ENFIELD INTERMODAL (MP05\_0147) - PRECINCT E ARCHITECTURE PLAN SIGN OFF -  
CONDITION 1.8

I refer to the below Precinct E plan which the Department approved pursuant to Condition 1.8 of the Enfield Intermodal consent on 6 March 2020.

Figure 2 - Updated Precinct E plan for DPIE review / approval

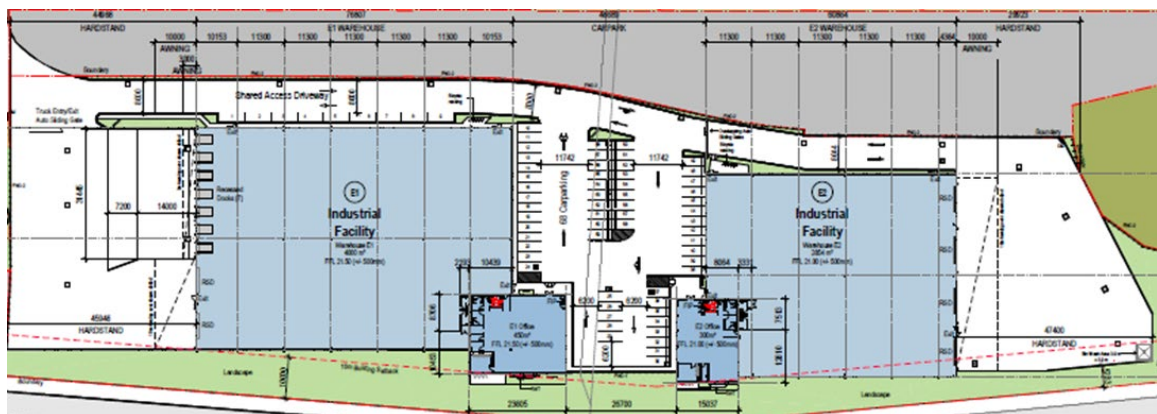
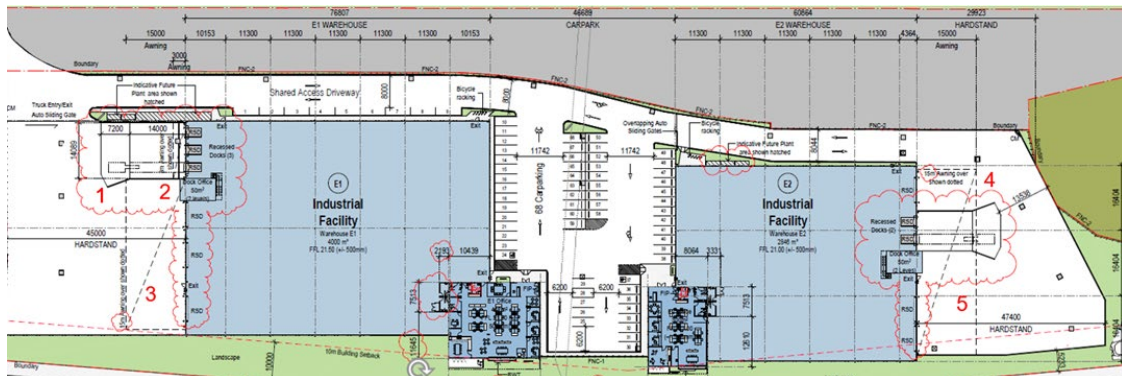
Since the Precinct E plan approval, the customer has requested a few very minor changes to the plans. While the certifier may be able to sign these updates as being 'consistent' with the approved, it's our preference to obtain DPIE approval of the changes under Condition 1.8. These changes are included in Fig.2 below (see numbered items 1-5 in Fig.2 below), and listed below:

- 1) Reduction of recessed docks for from seven (7) to three (3)
- 2) New dock office (442sqm)
- 3) Awning increased from 10m to 15m

- 4) Two (2) new recessed docks added
- 5) Awning increased from 10m to 15m

- No change to the approved building footprint, height, façade material, presentation, bulk & scale and landscaping.
- The updated building area remains compliant with Condition 1.6, with proposed building area no greater than 7,604sqm.
